Final Response : Technical note: HydroModPy – a Python toolbox for deploying catchment-scale shallow groundwater models

Referee comments on "Technical note: HydroModPy – a Python toolbox for deploying catchment-scale shallow groundwater models" by A. Gauvain et al., Hydrology and Earth System Sciences Discussions., <https://egusphere.copernicus.org/preprints/2026/egusphere-2026-868/>.

1 RC2: "Comment on egosphere-2026-868", Anonymous Referee 2, 19 May 2026

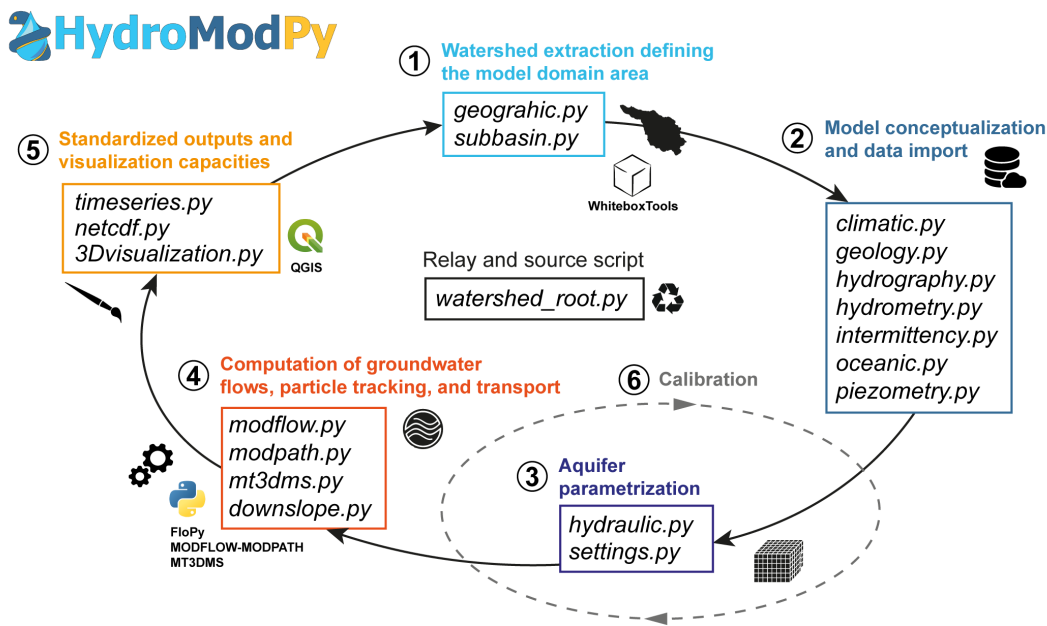
Line 114, Figure 1: Why is model calibration not a step in this workflow overview if it is quite central for model development?
 45 Agreed. In this version of HydroModPy, the calibration step is still under development and not yet fully integrated into the automated workflow. However, we recognize its importance and are actively working on incorporating it. We clarified this in the text and updated Figure 1 to include calibration as a key step in the workflow, even if it's currently a manual process that will become more automated in future versions.
